Access Compliance Report

Public Rights-of-Way

Intersection ID: 54043	Main Street: ELEVATION_POINT_DR	Cross Street: BALLANTYNE_GREEN_DR	Location: NE
ADA ID: 51AA7CC1175A	Ramp Type: Directional1	Initial Pass/Fail: Fail	Overall Compliance: No
		Severity Score: 1.25

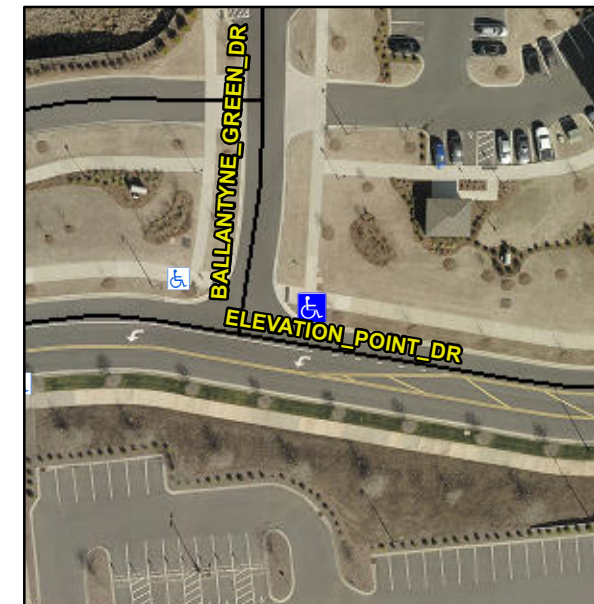
R304.5.3

Compliance	Description	Data	Compliance	Description	Data
N/A	Ramp Length (in)	117.5	N/A	Grade Break?	N/A
Yes	Ramp Width (in)	96.0	N/A	Grade Break Slope (%)	0.0
Yes	Ramp Slope (%)	5.7	N/A	Grade Break XSlope (%)	0.0
No	Ramp XSlope (%)	2.2			
N/A	Flare Type LT	N/A	N/A	Flare Type RT	N/A
N/A	Flare Slope LT (%)	N/A	N/A	Flare Slope RT (%)	0.0
N/A	Flare Traversable LT?	N/A	N/A	Flare Traversable RT?	N/A
N/A	Landing Length (in)	0.0	N/A	DWS Provided?	N/A
N/A	Landing Width (in)	0.0	N/A	DWS Contrast?	N/A
N/A	Landing Slope (%)	0.0	N/A	DWS Length (in)	N/A
N/A	Landing X Slope (%)	0.0	N/A	DWS Full Width?	N/A
N/A	Landing Curb? (Y/N)	N/A	N/A	DWS Offset LT (in)	N/A
N/A	Shared Landing?	N/A	N/A	DWS Offset RT (in)	N/A
N/A	Gutter Ponding?	0.0	N/A	Gutter Slope (%)	N/A
N/A	Gutter Lip Ht (in)	0.0	N/A	Gutter X Slope (%)	N/A
N/A	Painted X Walk1?	No		Road Slope (%)	1.2
	X Walk 1 Direction	To W		Road X Slope (%)	2.6
	X Walk 1 Width (in)	N/A		Clear Space?	N/A

Remove & Replace Entire Ramp.
